ORLANDO HEALTH
166 INPATIENT BED
VIERA HOSPITAL

DEPARTMENT FUNCTION
ROOM FLOOR PLAN -
LEVEL 03

G-403

Project Status
SCHEMATIC DESIGN

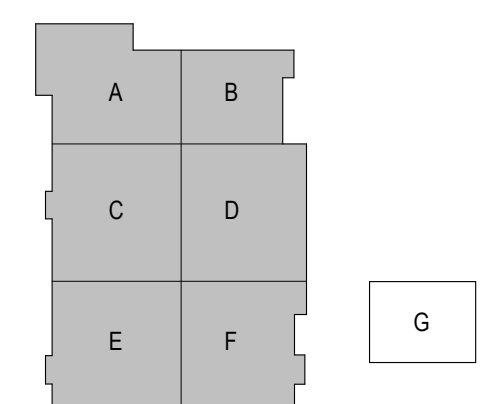
Office here on level 4

Office walls currently shown aligning with exterior mullions. Alternatively could jog the walls to equalize the office sizes

4 offices to be same size

President (not CEO) is the only large office

Move Intensivist office down into ICU (was about 50 feet north)

Need to maintain dead-end corridor less than 20 feet

Extend multi-purpose room and have glass as corridor end

Specialty room count/location same for all floors

Swap with Nurse Manager office so Lactation is on the edge of the unit

Aisle with POCT counter ideally would be 6'

Aisle ideally would be 4'

Check if aisle widths can be more narrow. Mike suggests using 5' 6" here since POCT is shifting away

Dictation door to nurse station not side corridor

1 controlled public entry
